CHANGE ORDER REQUEST

No. COR 094R-3

Project Name Tolleson Union High School No 7

Scope Description

OVERALL CIVIL SITE PLAN

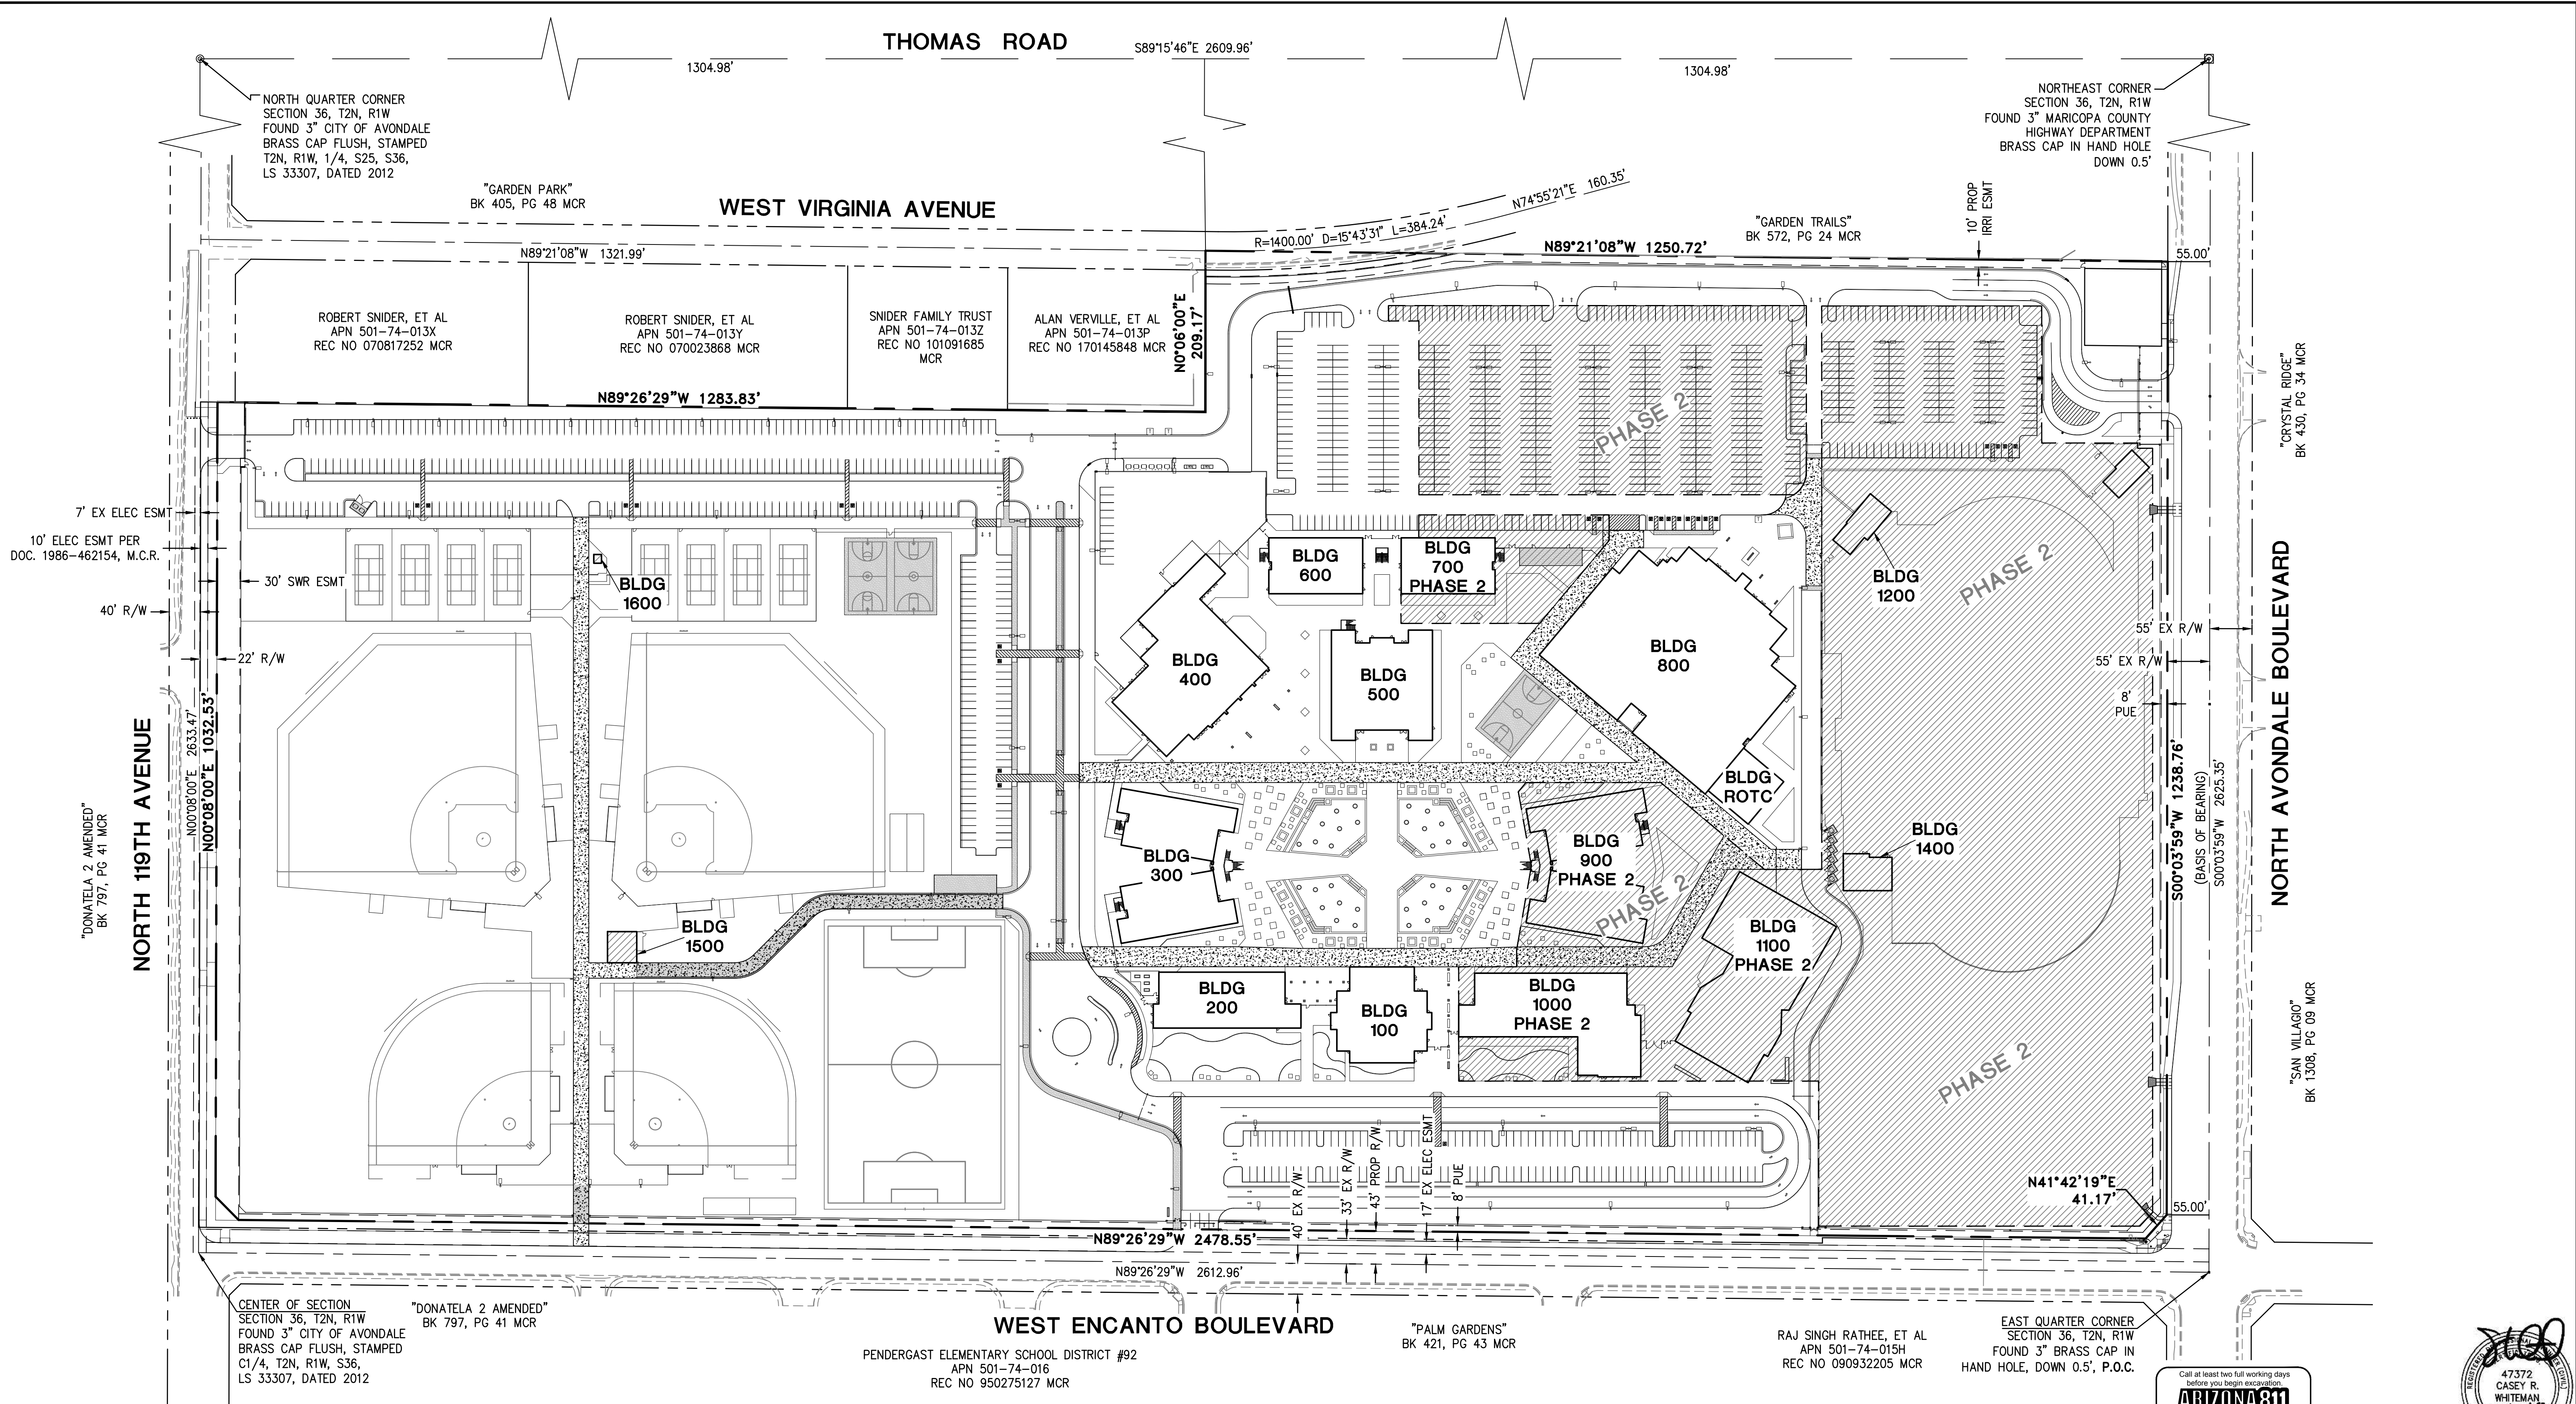
Provide additional trenching and conduit in Right of Way along Encanto Blvd as required by regulatory agencies (SRP), adjacent to the school's property for overhead to underground conversion of Electrical Power. Also added additional conduits for Cox/CenturyLink for future expansion.
